JEFFERSON MS NEW CONSTRUCTION
823 ACACIA STREET
OCEANSIDE, CA 92054
OCEANSIDE UNIFIED S.D.

Request for Information 032

Note 2 / sheet EL3-2
EL3-1

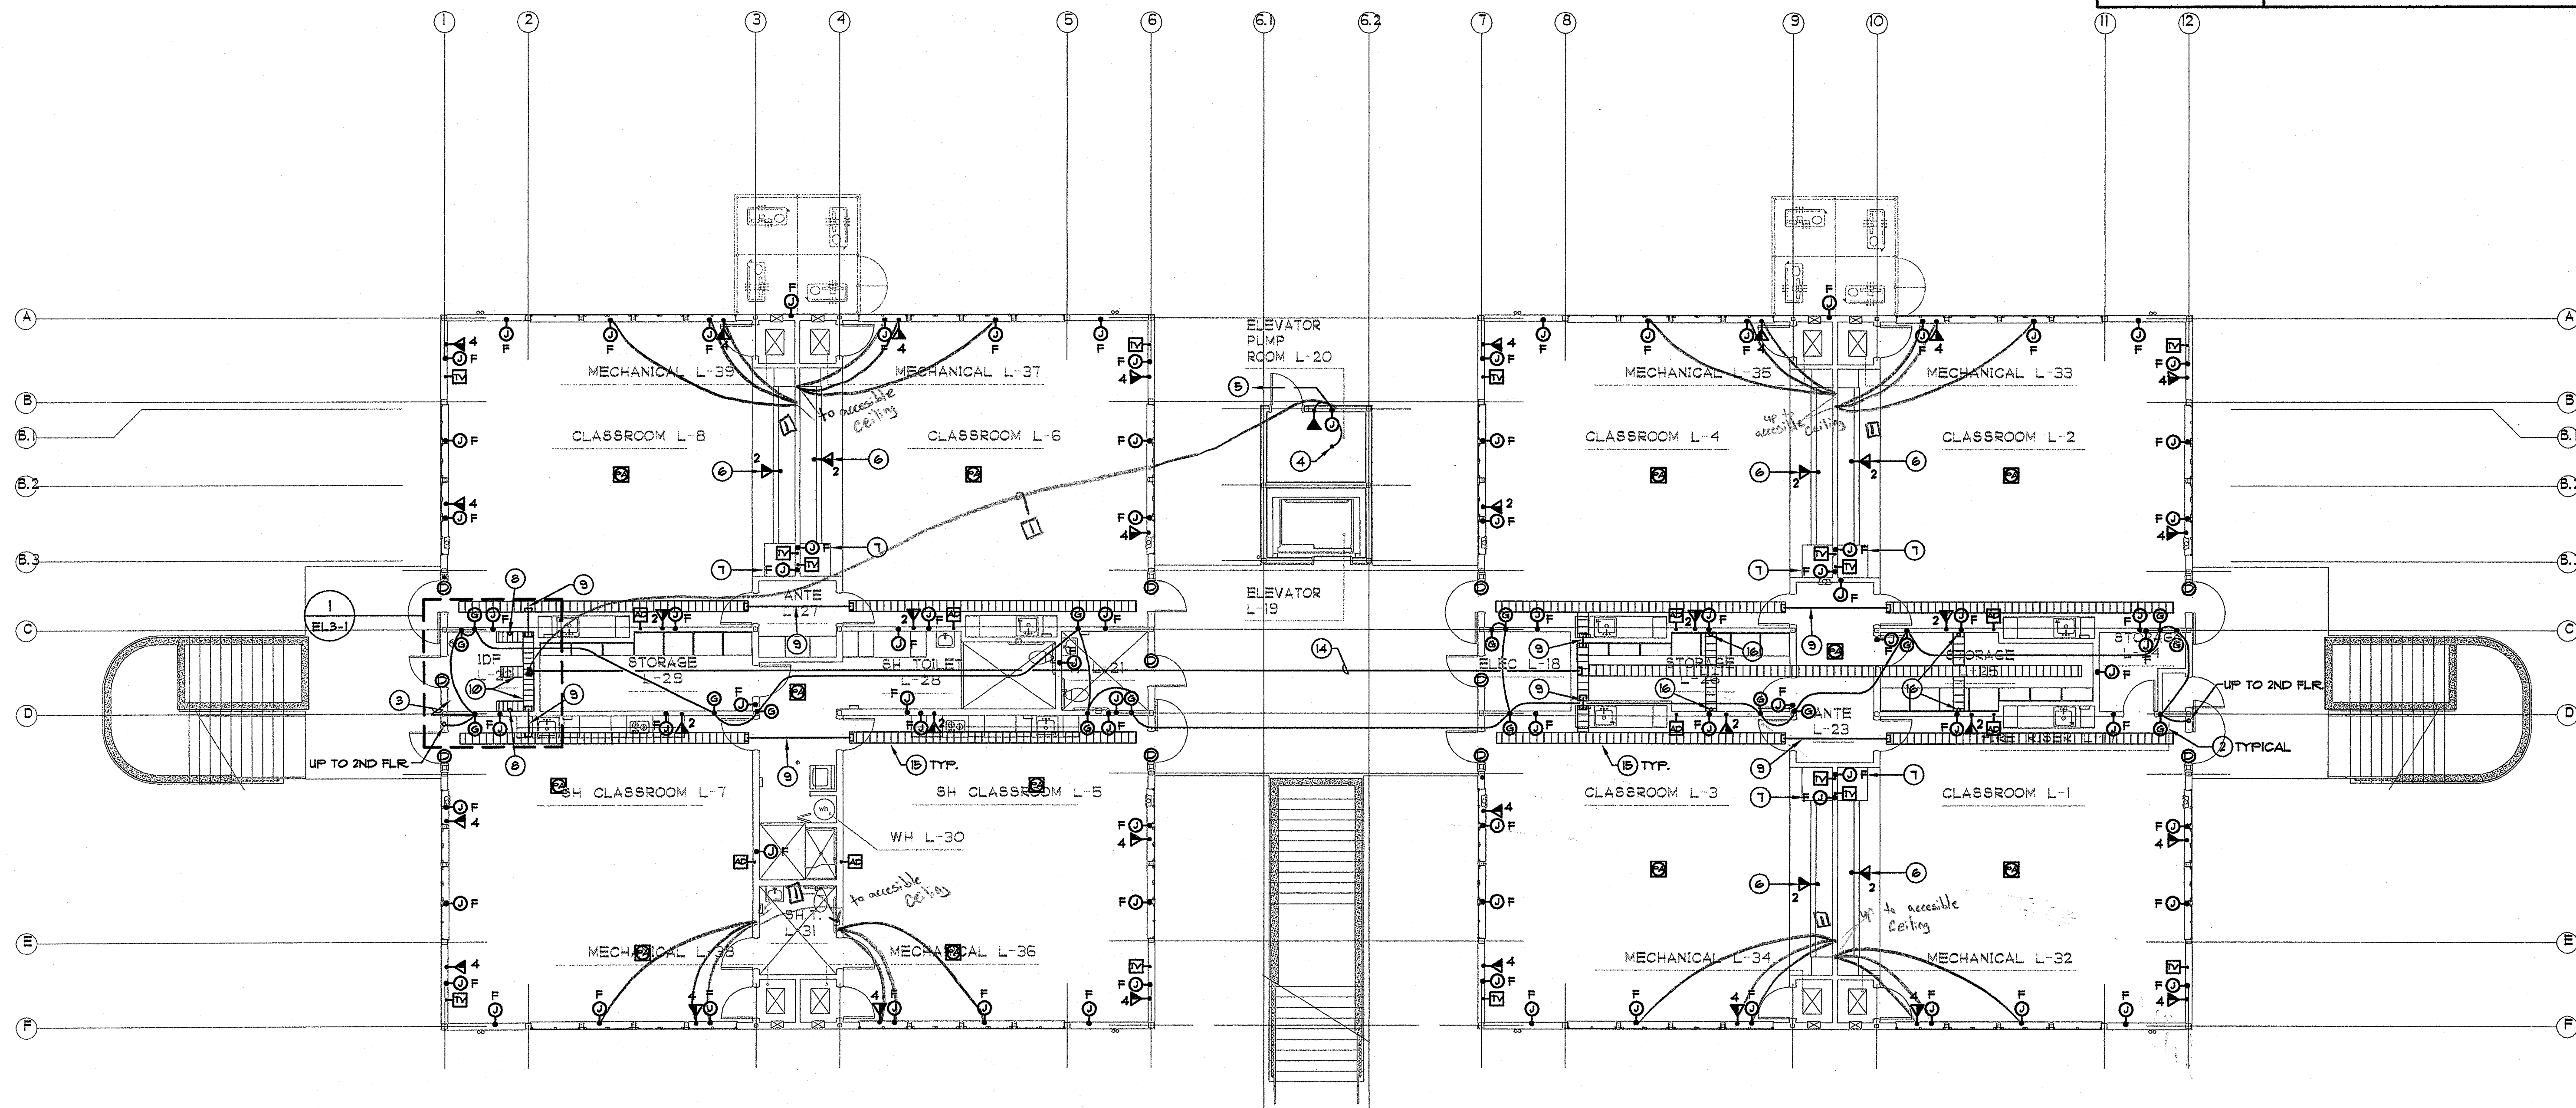
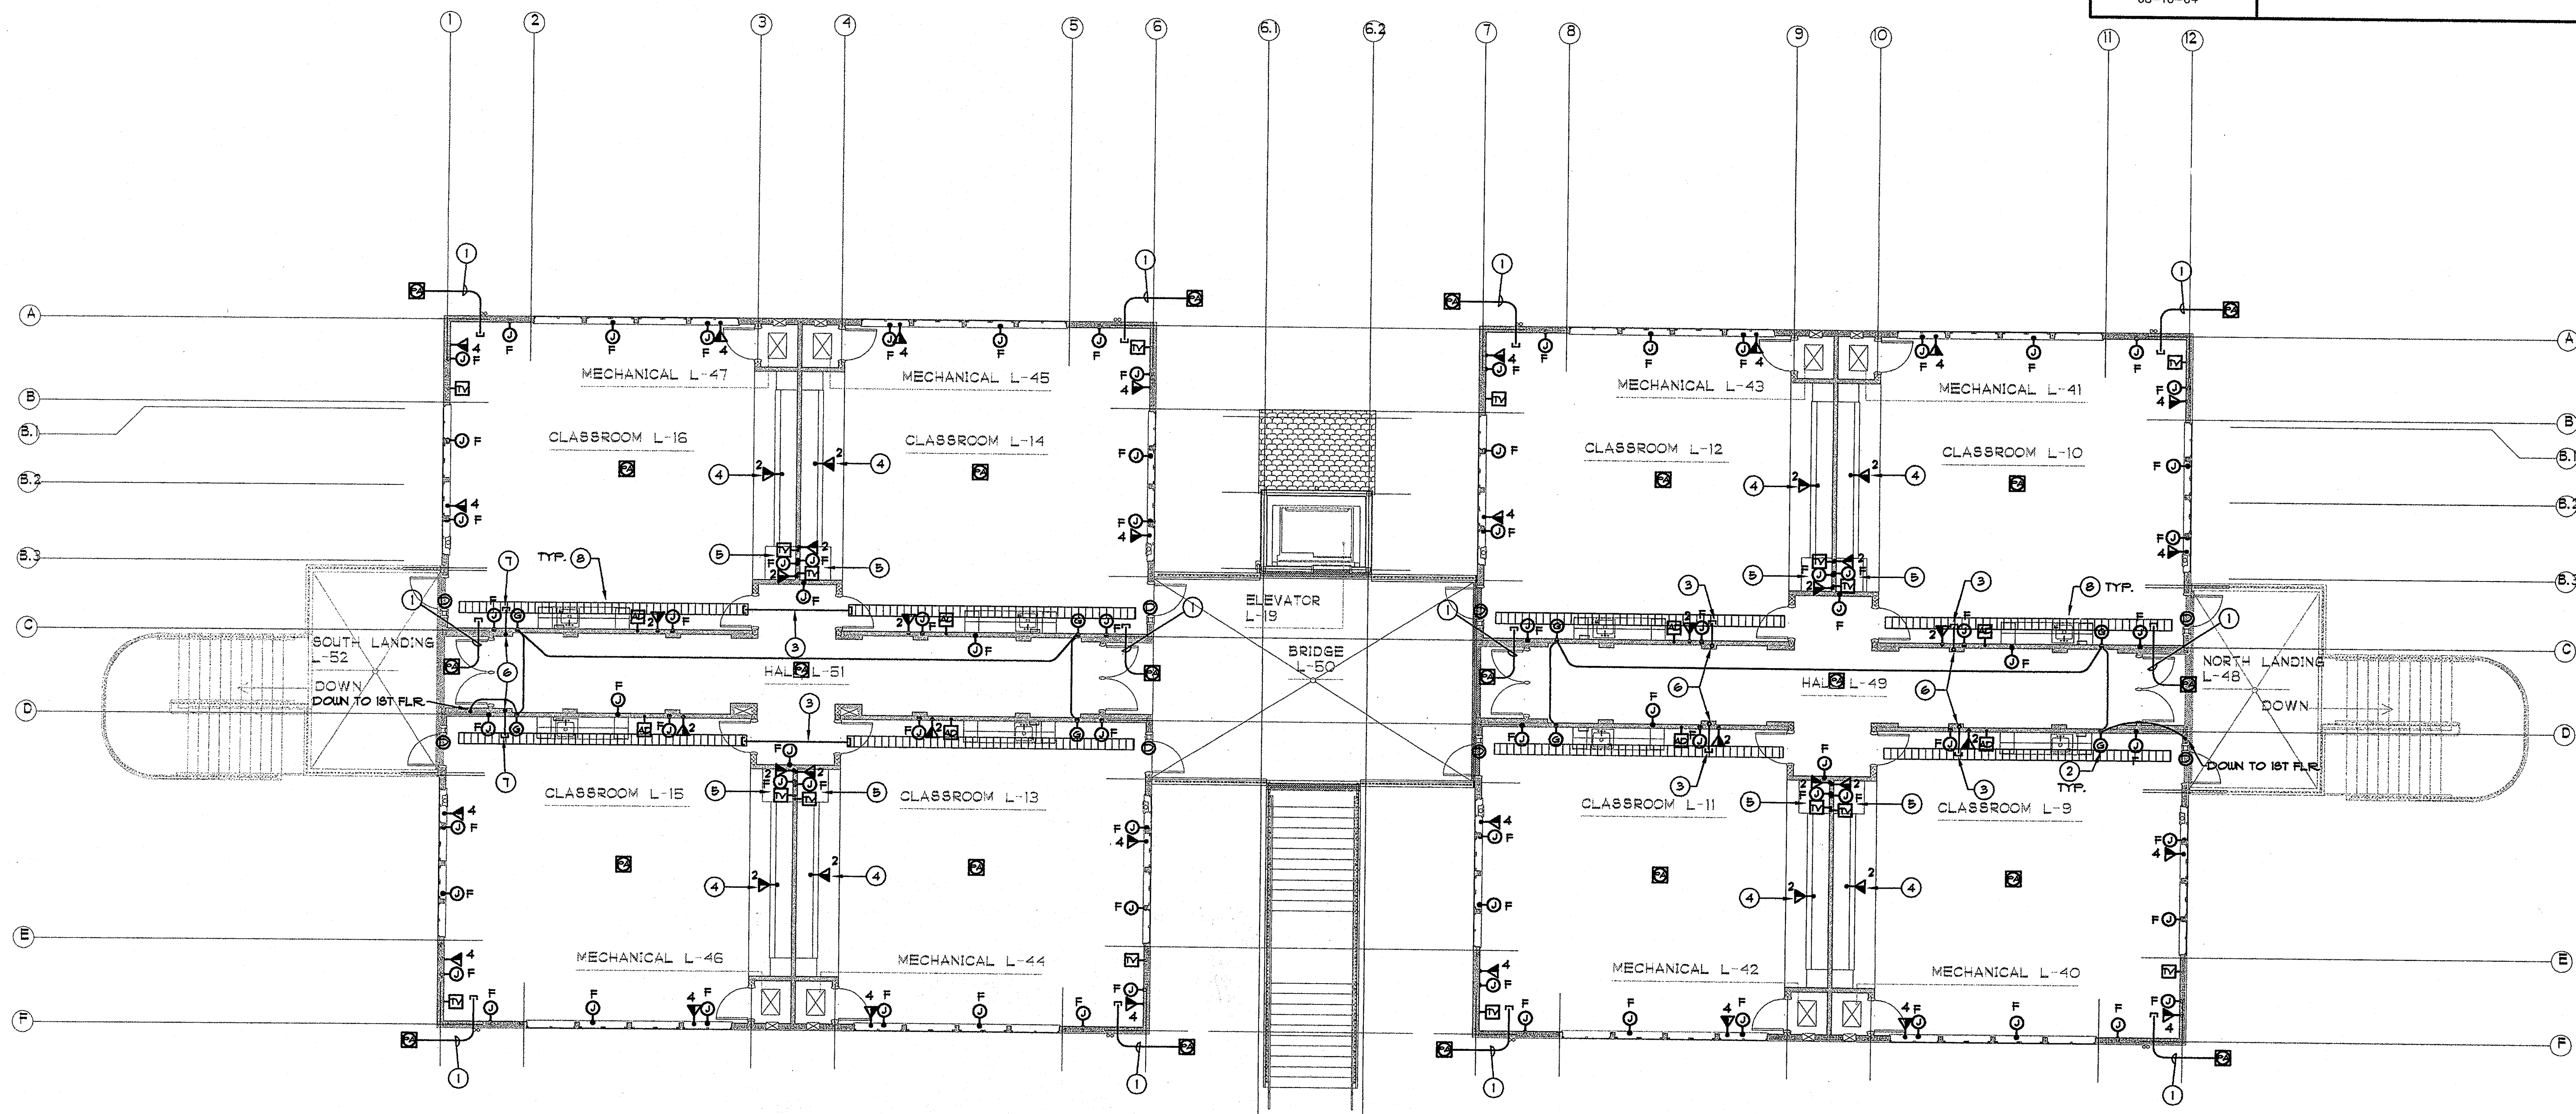
Question
Referencing Sheet EL3-1 and EL3-2 note 2 states Methane gas detector. Install 1'-0" below finish ceiling per manufacturer's instructions. There is no specification for this device or work. Please Clarify.
Date Required: 5/13/2005

Methane Detectors Shall be by: Macurcos Inc. - Model GD-ZA
Hard copies & email PDF File sent as of 05/10/05 to Steve Shires, and Arthur-Serata.

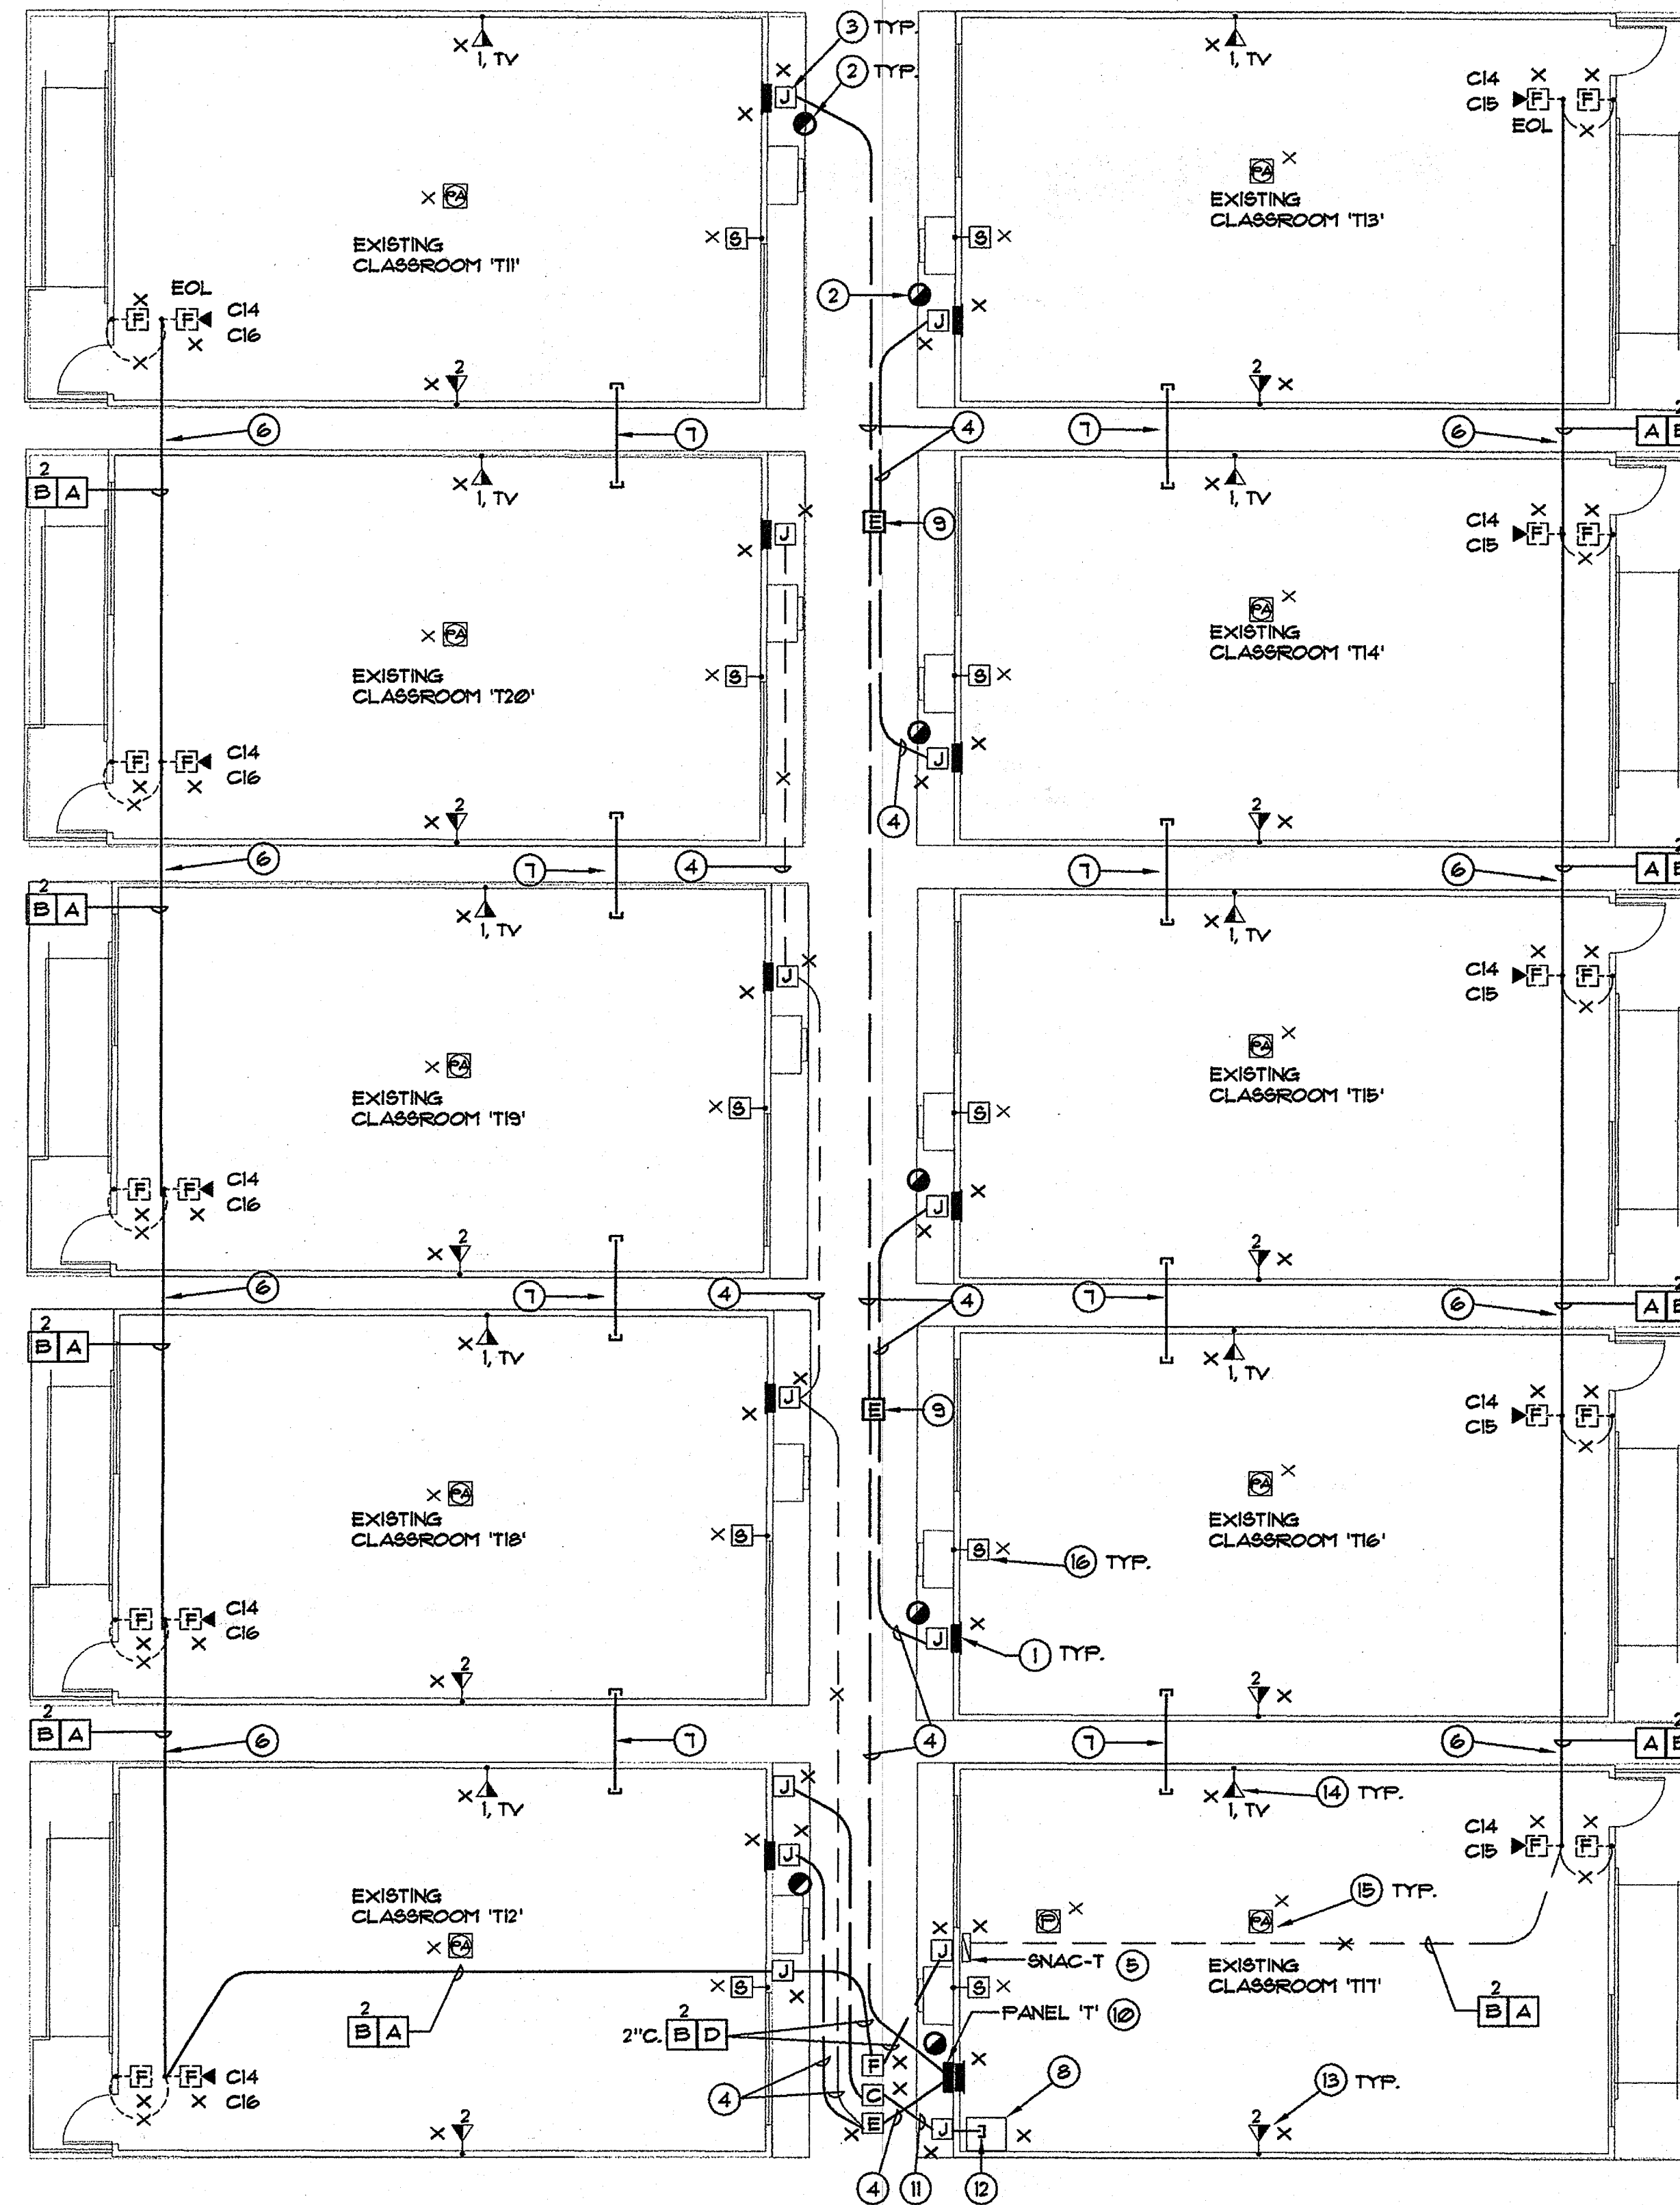
Question Date Required: 7/1/2005
Ref. ET-1.1 the three existing relocatable buildings T-18 - T-20 electrical is to remain un-touched. These buildings are fed underground to the first building T-18 then are surface piped between the other two with PVC on uni-strut. Due to the moving of the seven relocatables and the separation of the two rows we would need to excavate between. We are proposing to run rigid PVC schedule 80 surface mount to match the existing. Please advise if this is acceptable.

Answer Date Answered: 6/29/2005
Engineer's comments:
-proposed running of rigid pvc schedule 80 surface mount to match existing is acceptable.
